Access Compliance Report

Public Rights-of-Way

(Curb Ramps)

Intersection ID: 20640	Main Street: S_TRYON_ST	Cross Street: YAGER_CREEK_DR	Location: N
ADA ID: 5DBFACEF5C31	Ramp Type: Perp	Initial Pass/Fail: Fail	Overall Compliance: No
			Severity Score: 33.75

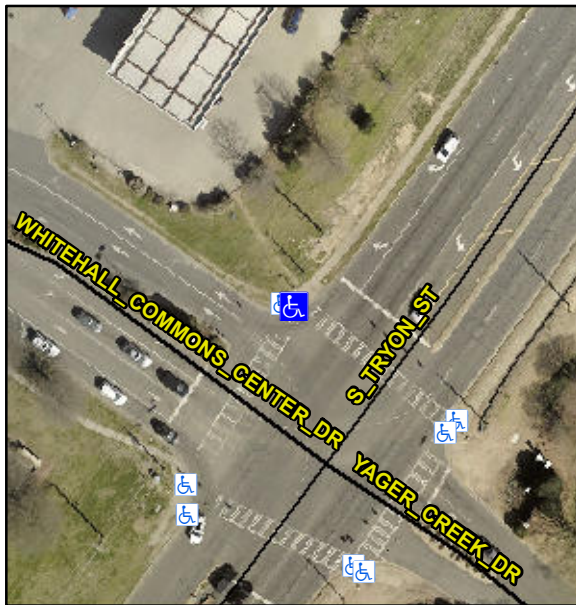
**Not Found, R304.5.1, R304.2.2,
R304.5.3**

Compliance	Description	Data	Compliance	Description	Data
N/A	Ramp Length (in)	89.0	No	Ramp Slope (%)	8.6
No	Ramp Width (in)	43.5	No	Ramp XSlope (%)	6.2
N/A	Flare Type LT	N/A	N/A	Flare Type RT	N/A
N/A	Flare Slope LT (%)	N/A	N/A	Flare Slope RT (%)	N/A
N/A	Flare Traversable LT?	N/A	N/A	Flare Traversable RT?	N/A
N/A	Landing Length (in)	N/A	N/A	DWS Provided?	N/A
N/A	Landing Width (in)	N/A	N/A	DWS Contrast?	N/A
N/A	Landing Slope (%)	N/A	N/A	DWS Length (in)	N/A
N/A	Landing X Slope (%)	N/A	N/A	DWS Full Width?	N/A
N/A	Landing Curb? (Y/N)	N/A	N/A	DWS Offset (in)	N/A
N/A	Shared Landing?	N/A			
N/A	Gutter Ponding?	N/A	N/A	Gutter Slope (%)	N/A
N/A	Gutter Lip Ht (in)	N/A	N/A	Gutter X Slope (%)	N/A
N/A	Painted X Walk1?	Yes	N/A	Painted X Walk2?	N/A
	X Walk 1 Direction	To SE		X Walk 2 Direction	N/A
N/A	X Walk 1 Width (in)	109.0	N/A	X Walk 2 Width (in)	N/A
	X Walk 1 Slope (%)	0.7		X Walk 2 Slope (%)	N/A
	X Walk 1 X Slope (%)	4.4		X Walk 2 X Slope (%)	N/A

**Remove & Replace Entire Ramp.
Restripe Crosswalk.**
